## SPACE X ANALYSIS OF THE EFFECT OF TERRESTRIAL MOBILE DEPLOYMENT ON NGSO FSS DOWNLINK OPERATIONS

### EXECUTIVE SUMMARY

**Figure 2. RKF and RS Access Plot B showing Macro Base Station antenna pattern with all sectors active, illustrating that nearly all far sidelobes are above -2.3dBi after considering all sectors**

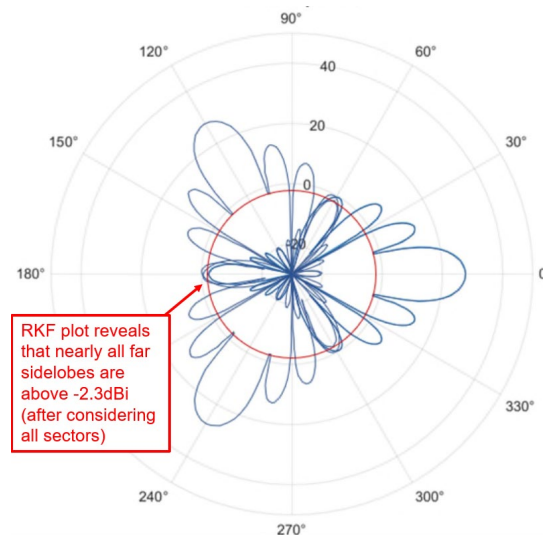
This analysis shows that ***even for best-case far-sidelobe-to-far-sidelobe coupling, the effect of harmful interference ( $I/N > -12.2\text{dB}$ ) will extend up to 21.4 km (more than 13 miles) from the macro base station in unobstructed conditions.*** RS Access and RKF themselves confirmed in their recent ex parte that the far sidelobe level is in fact -2.3dBi or higher after

considering all sectors, as shown in the figure reproduced below.<sup>36</sup> Importantly, this conclusion is consistent with the more reliable technical study the MVDDS licensees submitted in this docket (i.e., the First Peters Study).

Thus, a SpaceX user terminal (or any satellite earth station operating in the band) would be subjected to significant interference whenever located in the line of sight of a macro base station like the ones anticipated in the RKF Report.
